VOLUME 2 OF 2 - ZONING

Summary of Comments on P:\Projects\1216-00\BIM\Revit\Families\TITLEBLOCKS\EXTELL Proposal_atwalj.pdf

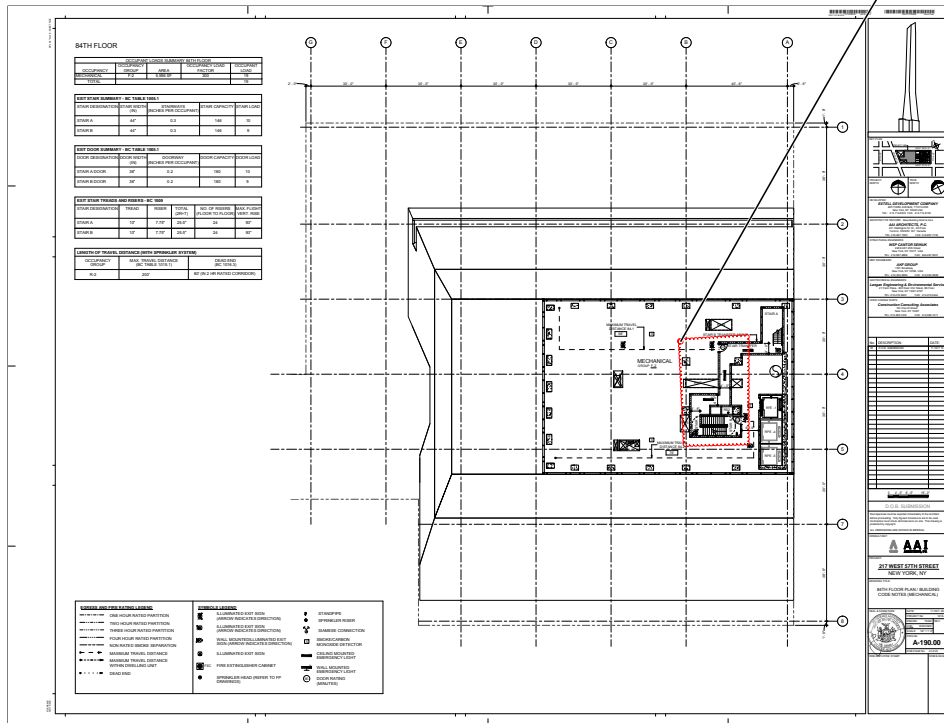
Author: dtitus Subject: Polygon Date: 1/4/2013 10:08:37 AM
A-occupancy

BC 403.11.1 Emergency power systems for assembly occupancy

1. Exit signs and means of egress illumination required by chapter 10.2.
3. emergency voice communications systems; and
4. Electrically powered fire pumps, unless electrical power to the motor is taken ahead of the main from the street side of the service switch.

Author: dtitus Subject: Polygon Date: 1/2/2013 11:59:00 AM
All interior stairs must lead to the roof as per BC 1009.12

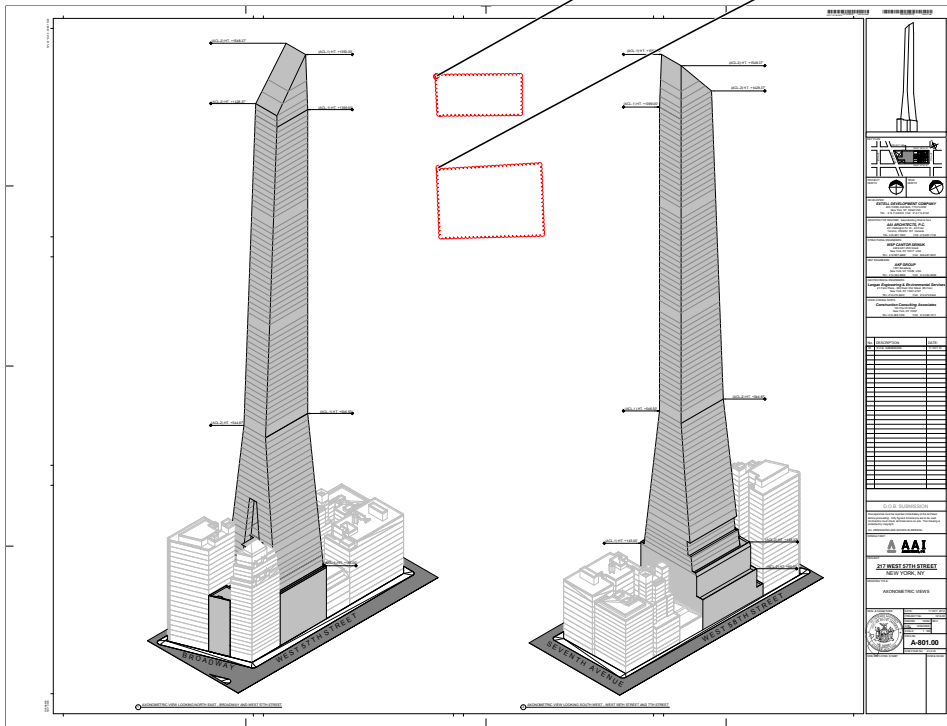
1 Provide all schedules windows, doors (indicate FPSC on all fire rated doors) etc.

Provide structural peer review report as per BC 1627.

Provide building elements, exterior walls of non-combustible construction with fire-resistance ratings for Type I-B construction (BC 602.1, BC 602.2).
